Service Center North Fuel Island Replacement

Bid # 23-49

ADDENDUM No. 1

November 6, 2023

PROJECT NO.: 00280
 DWG: **M04**
 SHEET: 14 OF 20
 DATE: OCT 2023
 REV: 0

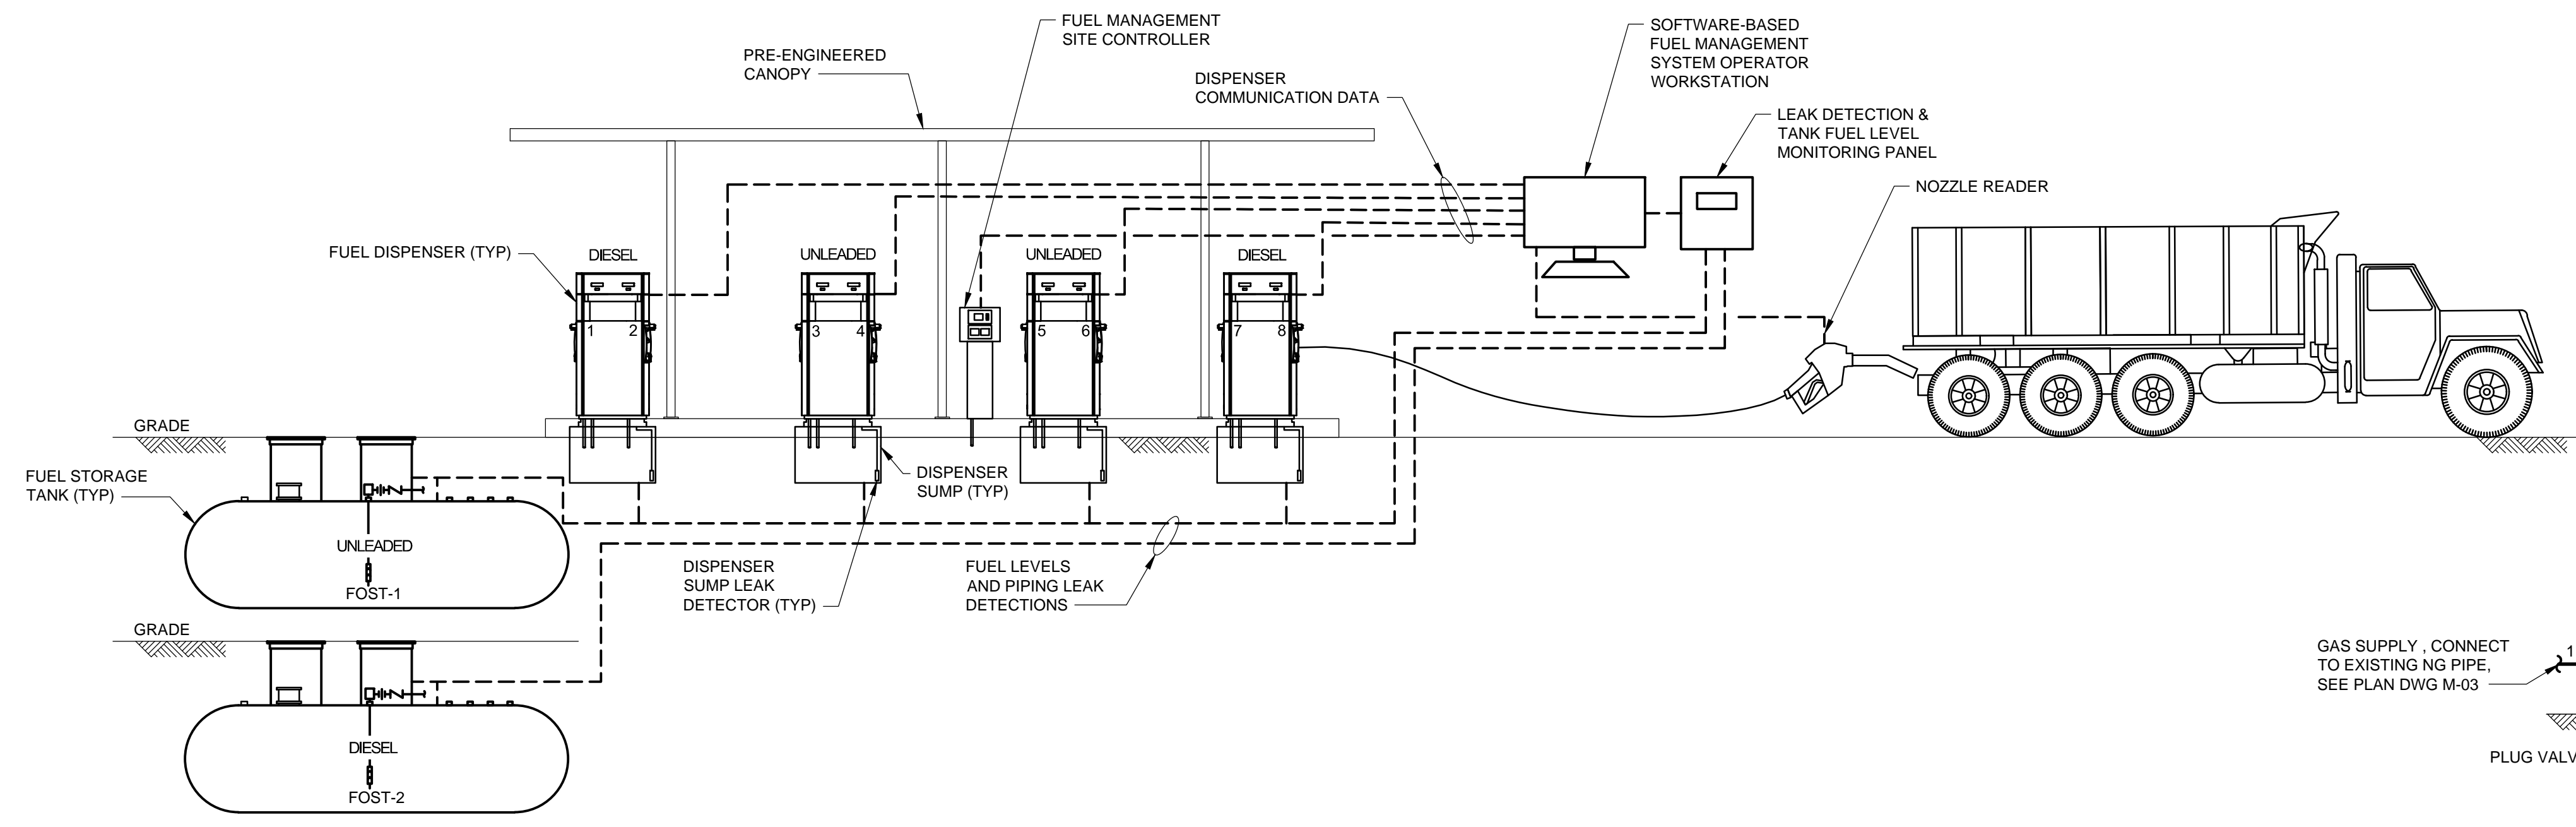
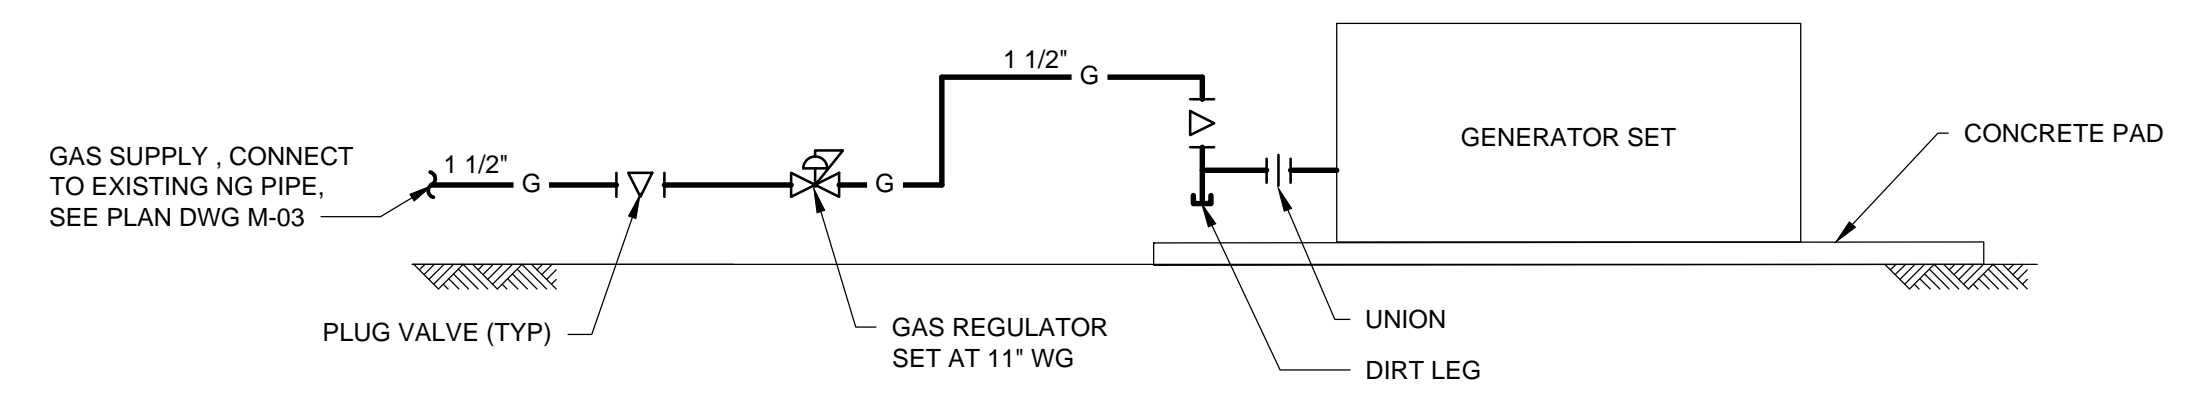
13. How many total hoses will the FMU (Fuel Management Unit) need to control? Looks like 8 from the drawing but just want to confirm.

Eight.

PROJECT NO.: 00280
DWG: M06
SHEET: 16 OF 20
DATE: OCT 2023
REV: 0

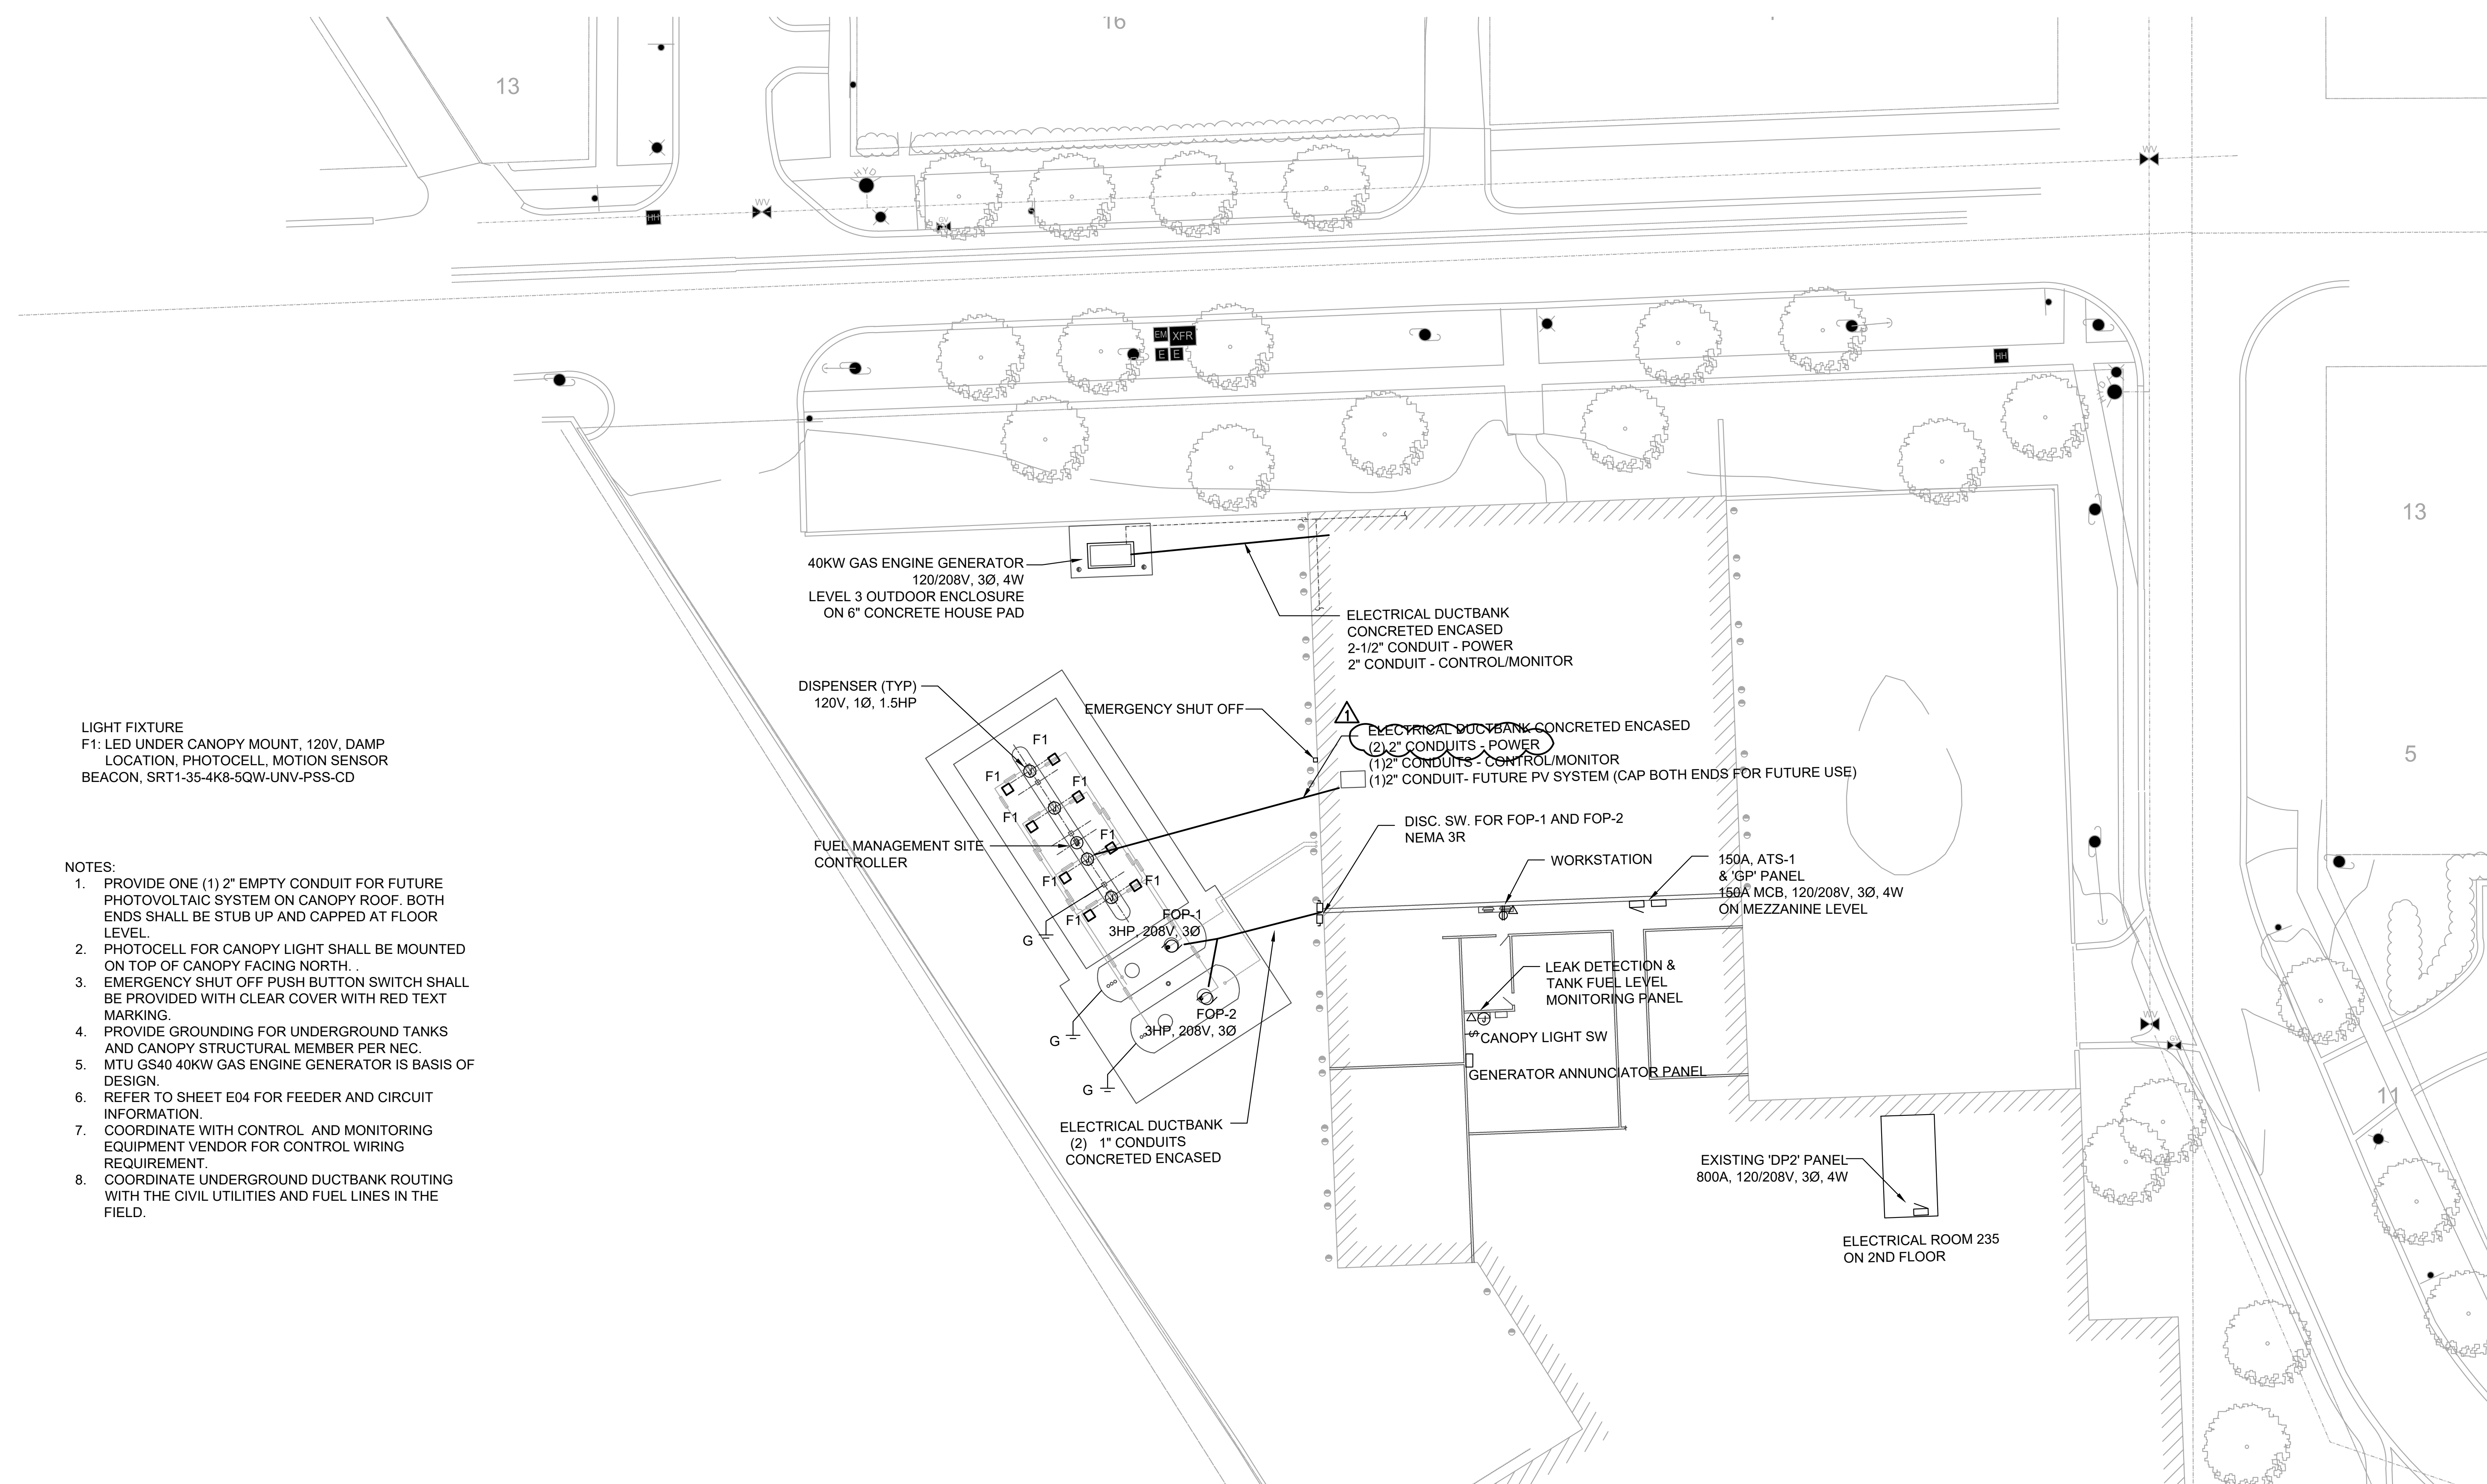
2. One the drawing M06 it shows 3/4" plywood sheeting. We have never installed plywood in this area and I believe this is not approved with the State Fire Marshal's office. We would use in this application a Slide Rail Shoring system which is removed once tanks are in and backfilled. We will place filter fabric on the tank bottom and side walls prior to backfill to prevent migration of outside soil/stone.

3. Also on Drawing M06 it shows installing a concrete anchoring pad. The industry does not do this as a standard any more due to additional cost for labor and materials to install it. This also takes longer to perform. Now we use preformed concrete dead men system that is provided by both specified tank manufactures. They are placed along side of the tanks and then anchored to the dead men with their tank straps and turnbuckle system. This saves a lot of install time on the install.

The City is open to considering alternate installation methods. Please refer to Section 01 63 00 Substitutions and Product Options for details on proposing substitutions Prior to Bid Opening, With Bid, and After Award of Contract.

The City is open to considering alternate anchoring methods that reduce installation time and cost. Please refer to Section 01 63 00 Substitutions and Product Options for details on proposing substitutions Prior to Bid Opening, With Bid, and After Award of Contract.
